NORTHEAST POWER COORDINATING COUNCIL, INC.
1040 AVE OF THE AMERICAS, NEW YORK, NY 10018 TELEPHONE (212) 840-1070 FAX (212) 302-2782

NPCC Request for Criteria Clarification

Task Force Response to Request for Criteria Clarification:
Criteria Clarification
Directory #1 for the New York State Reliability Council (NYSRC) Reliability
Rules Subcommittee

Figure 1

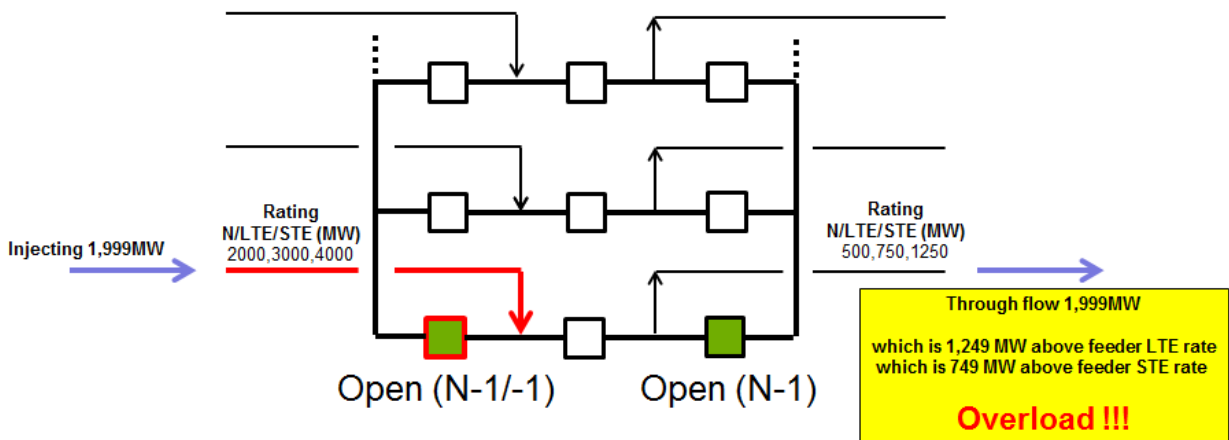
Under such N-1/-1 events, a high capacity injection (ex.: AC transmission, HVDC, or a generating unit) can be isolated onto a low rated transmission circuit (possibly loading it above its LTE or even its STE rate). Please see [Figure 1](#) below:

1. Why does NPCC Directory 1 omit N-1/-1 event such as open breaker followed by an open breaker?

A possible solution to the identified scenario above (Figure 1)* could be to open the middle breaker as a "system adjustment" within 30 minutes before the second contingency (in effect tripping the low rated transmission circuit). This action would eliminate the postulated overload illustrated in Figure 1.

2. Does NPCC Directory 1 postulate that the opening up of a circuit breaker falls within the definition of a "system adjustment"?

Why does NPCC Directory 1 omit N-1/-1 event such as open breaker followed by an open breaker?

Does NPCC Directory 1 postulate that the opening up of a circuit breaker falls within the definition of a "system adjustment"?

Planning scenarios in Table 1 are not expected to test all operating scenarios. The planning requirements in Directory 1 are used for the design and planning of the power system, while the operations requirements are applicable to operations scenarios. In the de-scribed scenario, after the first breaker opens, available control actions for operators such as opening a breaker or even taking a line out of service would result in a configuration that is covered by planning criteria.

While not specifically mentioned in Directory 1, opening up of a circuit breaker is a system adjustment to be considered in planning timeframe, provided it can be implemented within 30 minutes.
